**SUBDIVISION COMMITTEE  
METROPOLITAN AREA PLANNING COMMISSION**

**STAFF REPORT  
(Preliminary Plat)**

**CASE NUMBER:** S/D 97-41 HARVEST VALLEY ESTATES

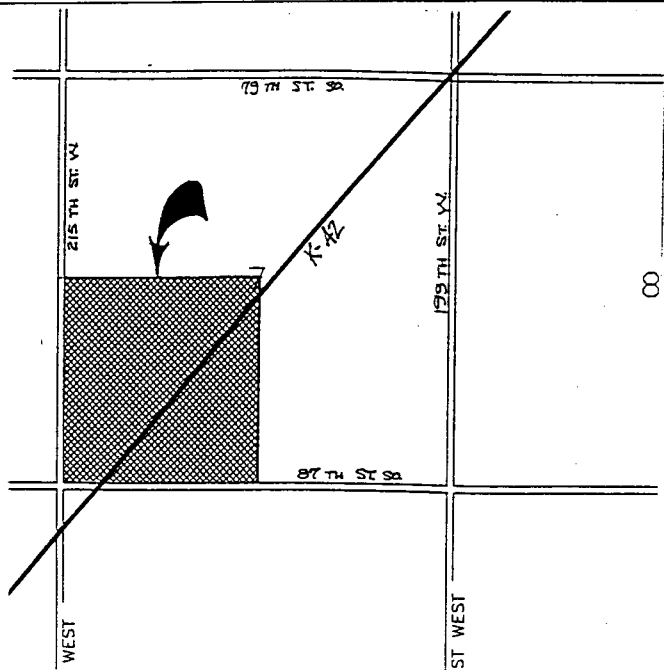
- A. Since neither municipal water nor sanitary sewer is available to serve this property, the applicant shall obtain a memorandum of approval for on-site systems from the Environmental Health Division of the Health Department.

- B. **County Engineering** needs to comment on the need, if any, for improvements to 215th Street West or 87th Street South.
  - C. The appropriate departments and affected agencies should comment on the suitability of the interior street layout, the number of intersections with K-42, and proposed access control. The word "complete" should be removed from any reference to access control which allows access. It cannot be complete access control if access is allowed. Also, should accel/decel and/or left-turn lanes be provided along K-42 at approved points of access?

- D. The applicant shall guarantee the installation of interior, residential streets to the gravel suburban residential street standard.
  - E. **County Engineering** needs to comment on the status of the applicant's drainage concept. The applicant shall guarantee the construction of any drainage improvements required by the platting of this property, including storm sewers.

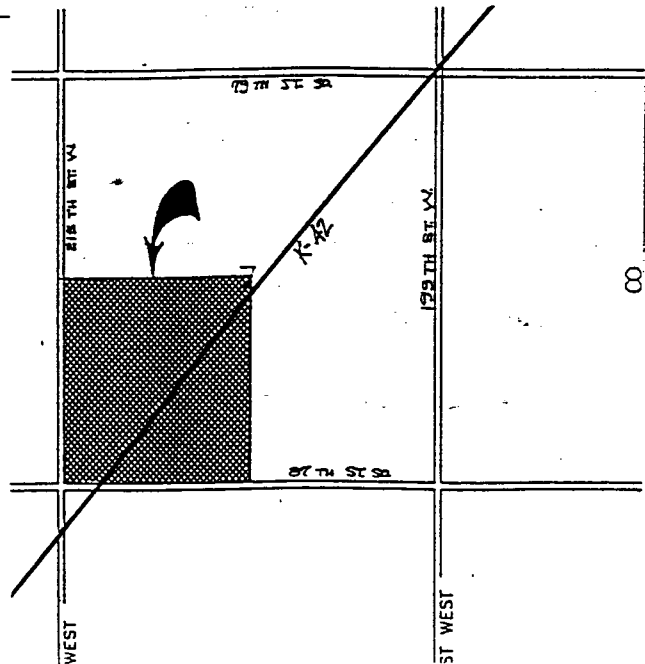
- A. Since neither municipal water nor sanitary sewer is available to serve this property, the applicant shall obtain a memorandum of approval for on-site systems from the Environmental Health Division of the Health Department.

- B. **County Engineering** needs to comment on the need, if any, for improvements to 215th Street West or 87th Street South.
  - C. The appropriate departments and affected agencies should comment on the suitability of the interior street layout, the number of intersections with K-42, and proposed access control. The word "complete" should be removed from any reference to access control which allows access. It cannot be complete access control if access is allowed. Also, should accel/decel and/or left-turn lanes be provided along K-42 at approved points of access?

- D. The applicant shall guarantee the installation of interior, residential streets to the gravel suburban residential street standard.
  - E. **County Engineering** needs to comment on the status of the applicant's drainage concept. The applicant shall guarantee the construction of any drainage improvements required by the platting of this property, including storm sewers.

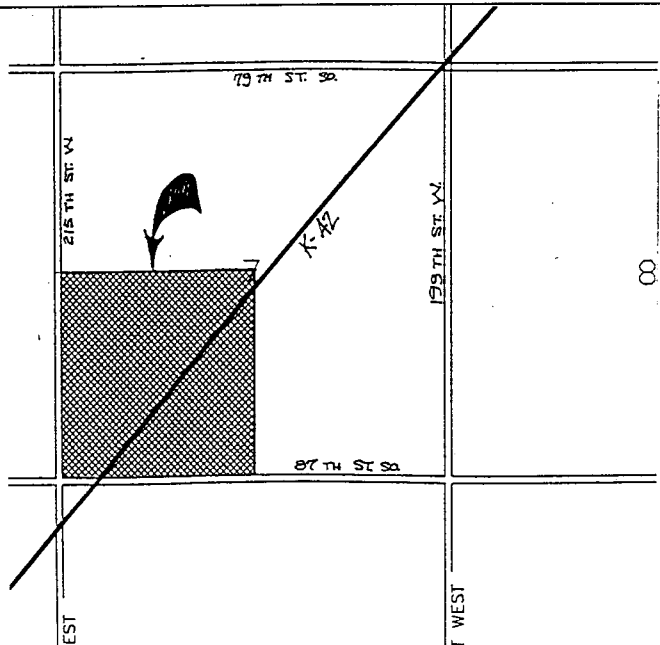
- A. Since neither municipal water nor sanitary sewer is available to serve this property, the applicant shall obtain a memorandum of approval for on-site systems from the Environmental Health Division of the Health Department. Health Department asks for additional soil tests.

- B. **County Engineering** needs to comment on the need, if any, for improvements to 215th Street West or 87th Street South.
- C. The appropriate departments and affected agencies should comment on the suitability of the interior street layout, the number of intersections with K-42, and proposed access control. The word "complete" should be removed from any reference to access control which allows access. It cannot be complete access control if access is allowed. Also, should accel/decel and/or left-turn lanes be provided along K-42 at approved points of access?

- D. The applicant shall guarantee the installation of interior, residential streets to the gravel suburban residential street standard.
- E. **County Engineering** needs to comment on the status of the applicant's drainage concept. The applicant shall guarantee the construction of any drainage improvements required by the platting of this property, including storm sewers.

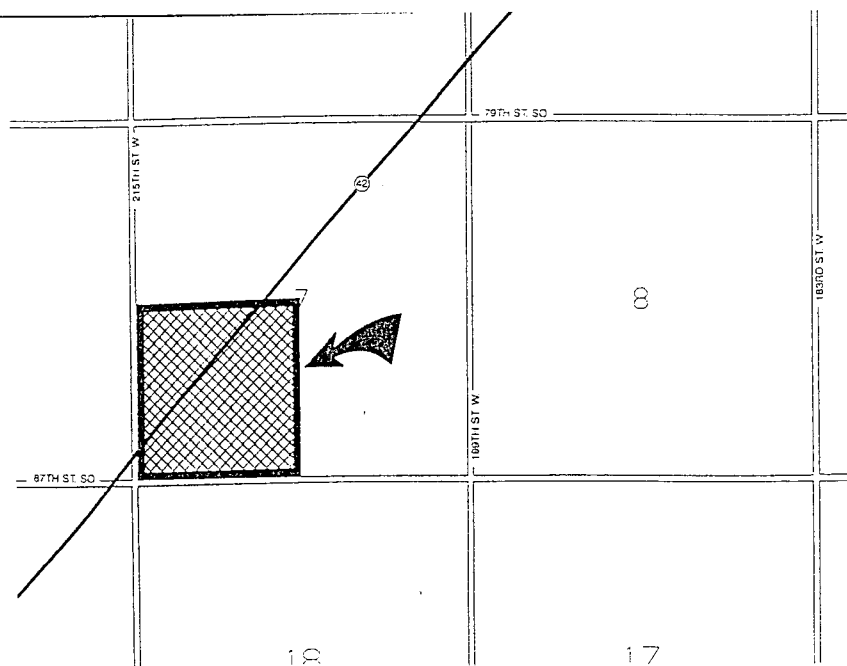
- A. Since neither municipal water nor sanitary sewer is available to serve this property, the applicant shall obtain a memorandum of approval for on-site systems from the Environmental Health Division of the Health Department. Health Department asks for additional soil tests. A memorandum of approval for on-site systems has been obtained.

- O. The zoning ordinance requires a setback of 125 feet from the centerline of the right-of-way of K-42.
  - P. The zoning ordinance requires a 30-foot setback for the interior streets. The applicant is advised that the current platting of a 35-foot setback would apply if platted as shown.

- Q. Lot 2 of Block 4 does not conform with the 200-foot lot width requirement. An increase in the distance of the building setback from the road would meet the standard.
-

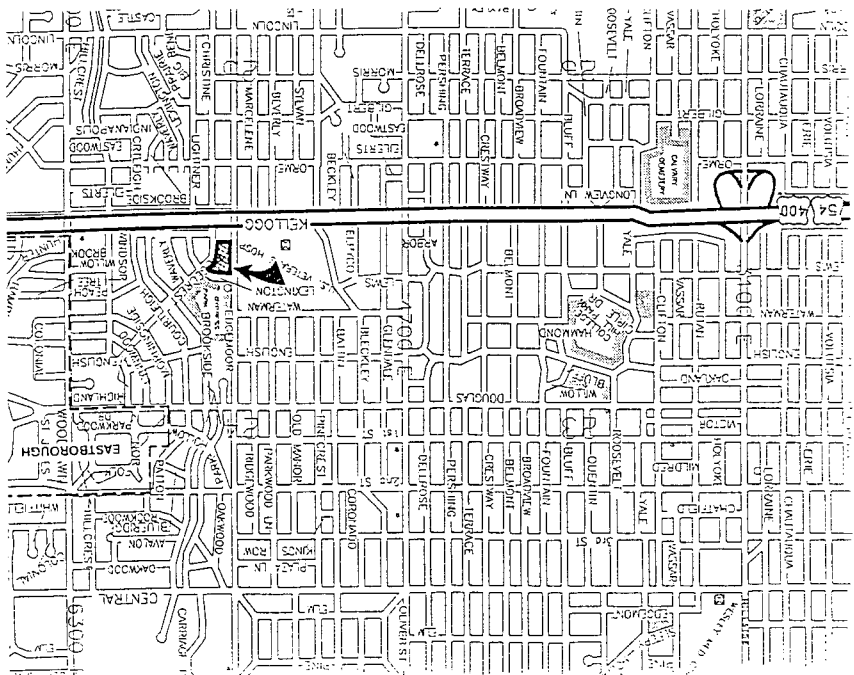
- A. It appears existing sewer and water service are available to the site. Engineering will need to comment on any guarantees or easements needed.
  - B. **Engineering** needs to comment on the status of the applicant's drainage concept.

- C. **Traffic Engineering** needs to comment on the acceptability of access controls. Distances should be shown for all segments of access control. On the final plat tracing, since the site is within the City limits of Wichita, the plat's text shall note that the access controls are being dedicated to the City of Wichita and that the location of the openings are subject to the approval of the City Engineer. The applicant shall guarantee the closure of any driveway openings being located in areas of complete access control or that exceed the number of allowed openings.

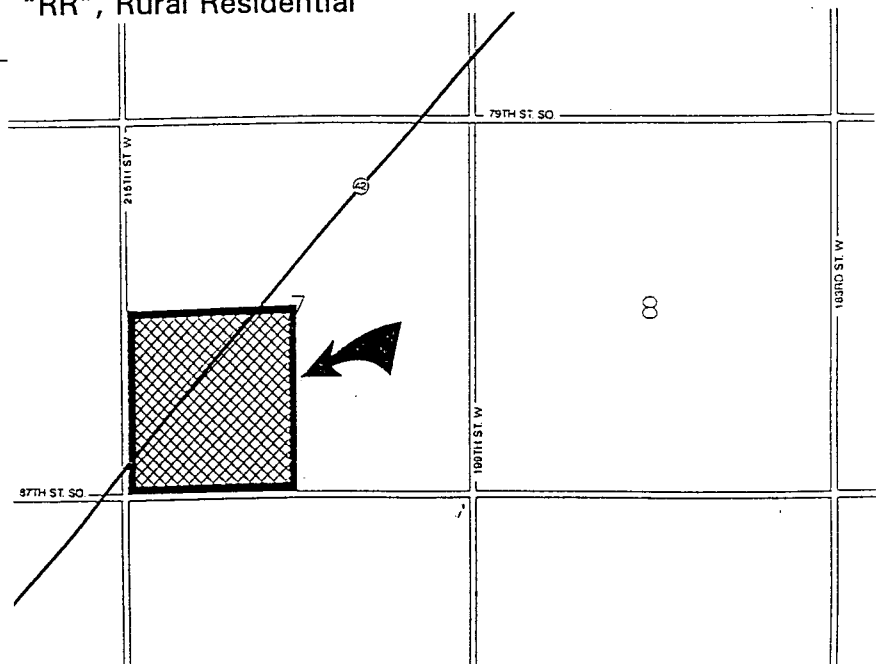
**County Health Department has revoked the memorandum of approval for on-site systems due to the revised lot layout. Lots 1 and 2 will need to be consolidated into one lot.**

- C. The **appropriate departments** and **affected agencies** should comment on the suitability of the interior street layout, the number of intersections with K-42, and proposed access control. The word "complete" should be removed from any reference to access control which allows access. It cannot be complete access control if access is allowed. Also, should accel/decel and/or left-turn lanes be provided along K-42 at approved points of access?

**The representative from Fire Department requested that Shade Street be renamed.**
- O. The zoning ordinance requires a setback of 125 feet from the centerline of the right-of-way of K-42.

- P. The zoning ordinance requires a 30-foot setback for the interior streets. The applicant is advised that the current platting of a 35-foot setback would apply if platted as shown.
- Q. Lot 2 of Block 4 does not conform with the 200-foot lot width requirement. An increase in the distance of the building setback from the road would meet the standard.

**County Engineering has indicated no need for improvements at this time.**

**County Engineering has indicated the proposed intersections with K-42 are unacceptable. A revised street layout is needed which includes Festival Street as a cul-de-sac; a loop street combining Harvest Valley Drive, Amber Ridge and Shade Court; and a cul-de-sac replacing the current Harvest Valley Drive intersection with K-42.**

- D. The applicant shall guarantee the installation of interior, residential streets to the gravel suburban residential street standard. **County Engineering has required the standard 36-foot wide gravel surface.**

**County Engineering has commented that the drainage concept is acceptable.**

***This item will not be applicable subject to the consolidation of Lots 1 and 2 per County Health Department's requirements.***

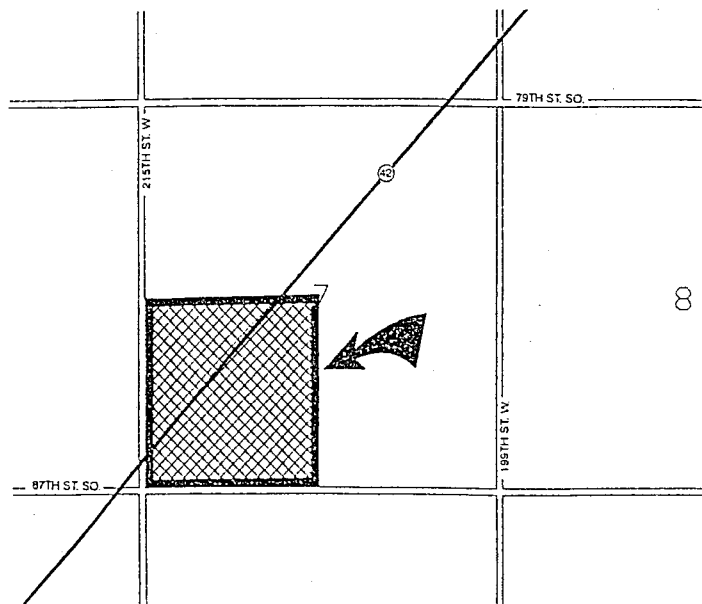
For Lot 9, Block 1, 100 feet of complete access control shall be dedicated along the southern frontage of the lot along 215th Street West. For Lot 3, Block 2, complete access control shall be dedicated for the north 100 feet and the south 100 feet of frontage along 215th Street West.

The final plat includes the requested access controls. However, Lot 3, Block 2, located on the southwest corner of the plat, now denotes access to 87th Street South, rather than 215th Street West as indicated on the preliminary plan.

County Engineering has commented that the drainage concept is acceptable. The drainage easements shall be shown on the final plat as a floodway reserve, and be a minimum width of 50 feet. The drainage easement on Lot 17, Block 2 shall be realigned to line up with the culvert under 87th Street South.

The final plat includes the requested revisions by County Engineering. On the final plat tracing, the centerline of the floodway reserves should be denoted by a dashed line. The platting text should note the creation of the Floodway reserves. County Engineering needs to comment on the status of the applicant's drainage plan.

- T. On the final plat tracing, the Chair of the MAPC should read Richard Lopez. The Deputy should read Michael D. Hurtt. The Chair Pro Tem should read Paul W. Hancock. Melody C. Miller should be spelled correctly.

The final plat includes a revised street layout as requested by County Engineering.

The final plat includes the above setback.
- R. The zoning ordinance requires a 30-foot setback for the interior streets. The applicant is advised that the current platting of a 35-foot setback would apply if platted as shown.
- S. Lot 2 of Block 4 does not conform with the 200-foot lot width requirement. An increase in the distance of the building setback from the road would meet the standard.
